# Access Compliance Report

### (Curb Ramps)

Intersection ID: 47911	Main Street: ROOK_RD	Cross Street: RINGNECK_RD	Location: SE
ADA ID: 926E5CD3B385	Ramp Type: PerpDiag	Initial Pass/Fail: Fail	Overall Compliance: No
Severity Score: 12.5			
Codes/Mitigation Info/Possible Solution		Field Measurements/Component Compliance

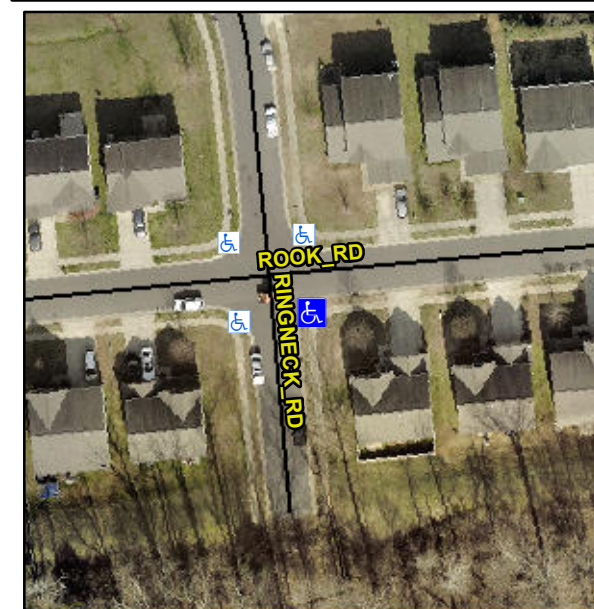
**Not Found, R304.2.2**

Compliance	Description	Data	Compliance	Description	Data
N/A	Ramp Length (in)	48.5	No	Ramp Slope (%)	8.9
Yes	Ramp Width (in)	48.0	Yes	Ramp XSlope (%)	1.6
N/A	Flare Type LT	N/A	N/A	Flare Type RT	N/A
N/A	Flare Slope LT (%)	N/A	N/A	Flare Slope RT (%)	N/A
N/A	Flare Traversable LT?	N/A	N/A	Flare Traversable RT?	N/A
N/A	Landing Length (in)	N/A	N/A	DWS Provided?	N/A
N/A	Landing Width (in)	N/A	N/A	DWS Contrast?	N/A
N/A	Landing Slope (%)	N/A	N/A	DWS Length (in)	N/A
N/A	Landing X Slope (%)	N/A	N/A	DWS Full Width?	N/A
N/A	Landing Curb? (Y/N)	N/A	N/A	DWS Offset (in)	N/A
N/A	Shared Landing?	N/A			
N/A	Gutter Ponding?	N/A	N/A	Gutter Slope (%)	N/A
N/A	Gutter Lip Ht (in)	N/A	N/A	Gutter X Slope (%)	N/A
N/A	Painted X Walk1?	No	N/A	Painted X Walk2?	No
	X Walk 1 Direction	To N		X Walk 2 Direction	To W
N/A	X Walk 1 Width (in)	N/A	N/A	X Walk 2 Width (in)	N/A
	X Walk 1 Slope (%)	2.2		X Walk 2 Slope (%)	2.8
	X Walk 1 X Slope (%)	0.6		X Walk 2 X Slope (%)	3.5

**Remove & Replace Curb Ramp With Two New Directional Ramps or Equivalent.**
